CITY OF MILWAUKIE

PLANNING COMMISSION

- 6.1 10586 & 10610 SE Home Ave

File: R-2021-004 (primary file), with VR-2021-019

Figure 1. Proposed Lot Configuration

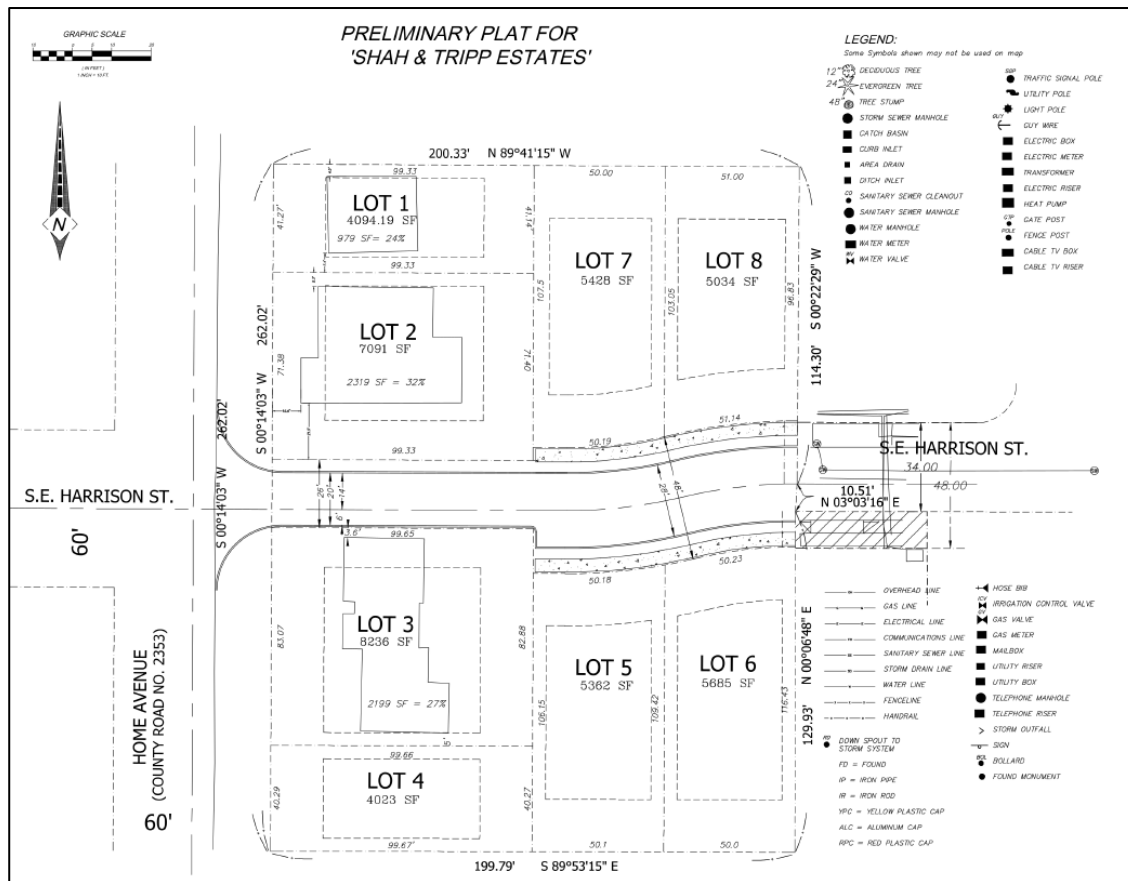
As shown in Figure 1, Lots 1-4 will front on Home Avenue; Lots 5-8 will have frontage on a full-width extension of Harrison Street from its current terminus within the adjacent Mission Park subdivision to the east. A narrower portion of Harrison Street between Lots 2 and 3 will connect to Home Avenue. The applicant has requested variances to reduce the lot width and lot area of Lots 1 and 4 below the minimum standards.

Figure 2. Revised roadway plan (Harrison Street extension)

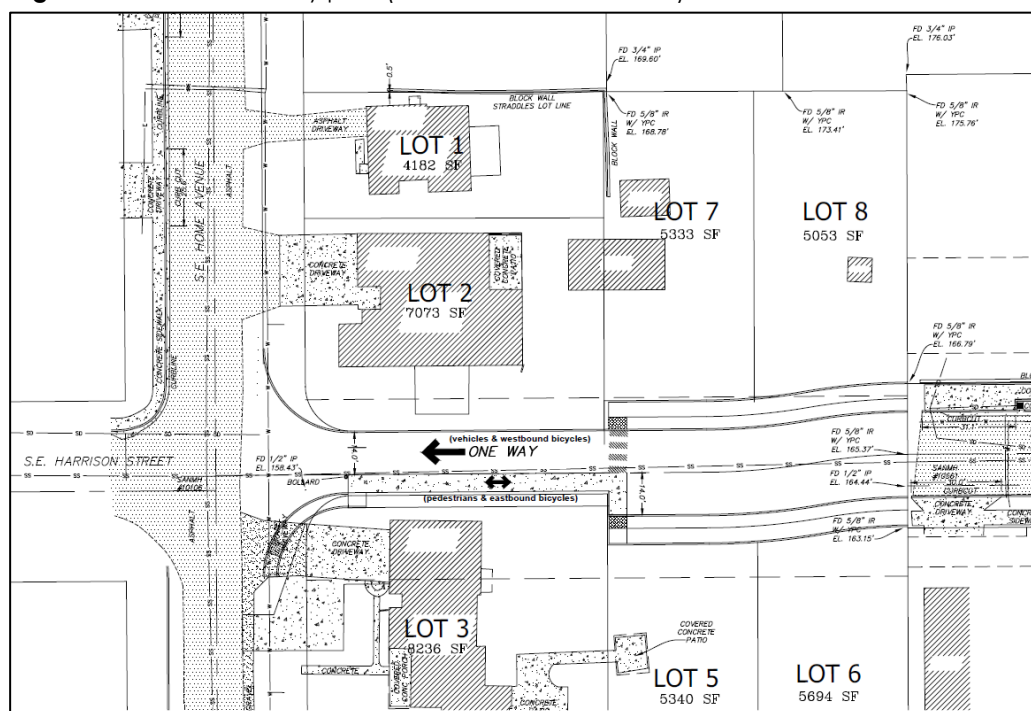
In response to public testimony in opposition to the proposed two-way street connection on Harrison Street to Home Avenue, the applicant provided a revised plan for the Harrison Street roadway (see Figure 2, next page). The revised roadway plan maintains bicycle and pedestrian traffic in both directions but allows only one-way (westbound) vehicle traffic. A concrete walkway is designated for pedestrian use, with bollards and/or removable signposts at the east and west ends of the narrower portion of the Harrison Street extension between Lots 2 and 3 that can be removed as needed to provide the required access for fire and emergency vehicles. The revised plan shifts the roadway alignment 5 ft to the north; this impacts the dimensions of Lots 2 and 3 but does not create the need for additional variances. See Attachment 6 for a revised version of the preliminary plat that reflects the realignment of the roadway and a more detailed survey of the subject properties.

For better functionality over the long term, the City's preferred design for the Harrison Street extension is for two-way vehicle traffic; however, the applicant's revised roadway plan allowing only one-way westbound vehicle traffic is an acceptable configuration. The one-way circulation plan maintains full access for bicycles and pedestrians, prevents the need for garbage trucks and delivery vehicles to turn around to exit the neighborhood, and provides an alternative route that should reduce the number of exit trips at the intersection of 51st Avenue

(Note: The applicant's revised roadway design does not necessarily represent the final construction plan, as it will be adjusted as needed to meet applicable Public Works standards as determined by the Engineering Department. For example, the applicant's revised design does not show a striped bicycle lane that will may be required to properly delineate the space where bicycles are expected to travel. It also shows only one bollard at the west end of Harrison Street, when at least one additional bollard or removable signpost at the east end of the narrower portion of the Harrison Street extension will also be required. Pavement markings, signage, and features such as a tactile warning strip will also be added to the final construction plan.

Attachment 3

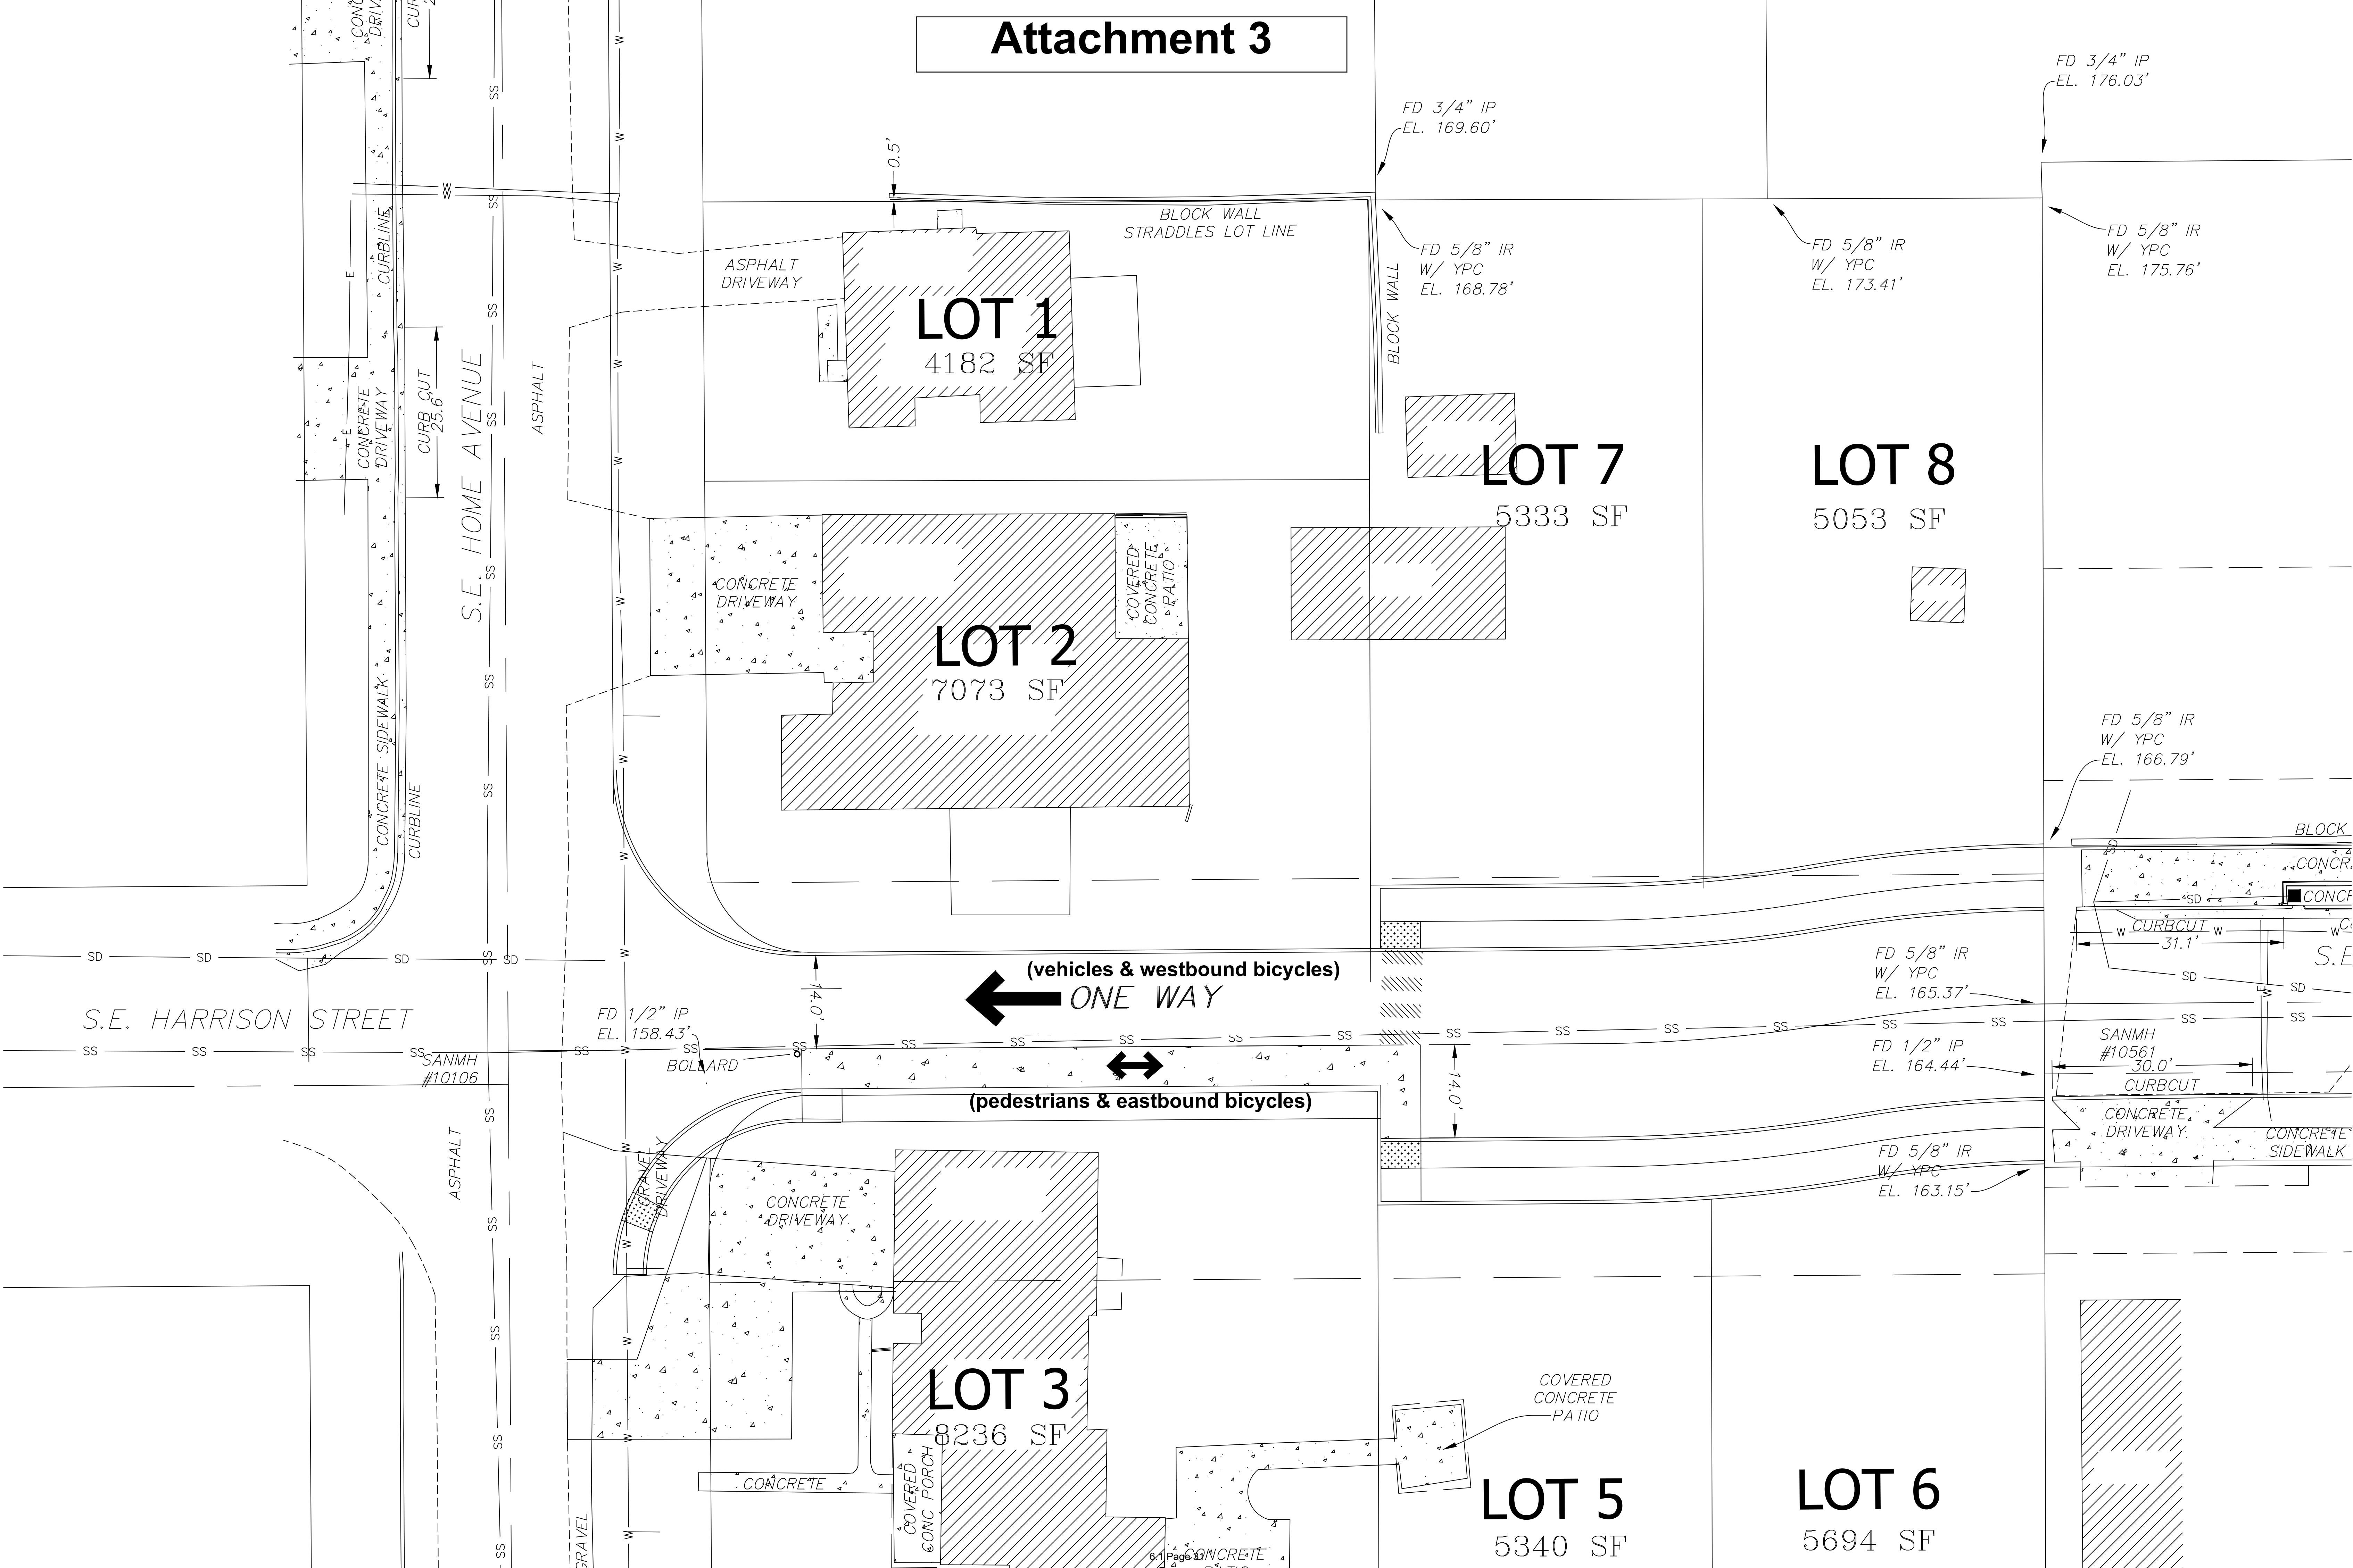
As addressed at the end of the March 22 meeting, the applicant proposed to revise the Harrison Street roadway plan (see Attachment 3) and to provide an opportunity for public comment on it. The following is a summary of the responses received by the City on the revised plan. See Attachment 4 for further details. The applicant's response to these public comments is included as Attachment 5.

In review of the drawing submitted by the developer for the Harrison Street project, we are still **STRONGLY OPPOSED**, to the street being opened, even as a one way, exiting west, towards Home Street.

None of the information provided by the developer gave us any reason to change our minds. I truly hope the City of Milwaukie takes into consideration the concerns of the Mission Park tax paying homeowners, and denies this Harrison Street proposal, to open Harrison Street to through or one-way traffic.

By creating a one-way access out of the development, as well as pedestrian, and bicycle access, that this property is now in compliance with the circulation, and street block standards that were previously not met. It has also removed the issue of a dead-end street which exceeded the maximum length of cul-de-sac. Lastly the construction of the street is in line with the City's Transportation plan and follows the adjacent subdivisions future street plan that was part of their approval. It takes the existing sanitary main out of private property ownership, and into a public right-of-way.

For these reasons we continue to support our proposal from last week. If staff can prepare conditions, and if we need to make any final design changes necessary to obtain preliminary approval the applicant will work with staff to do so.
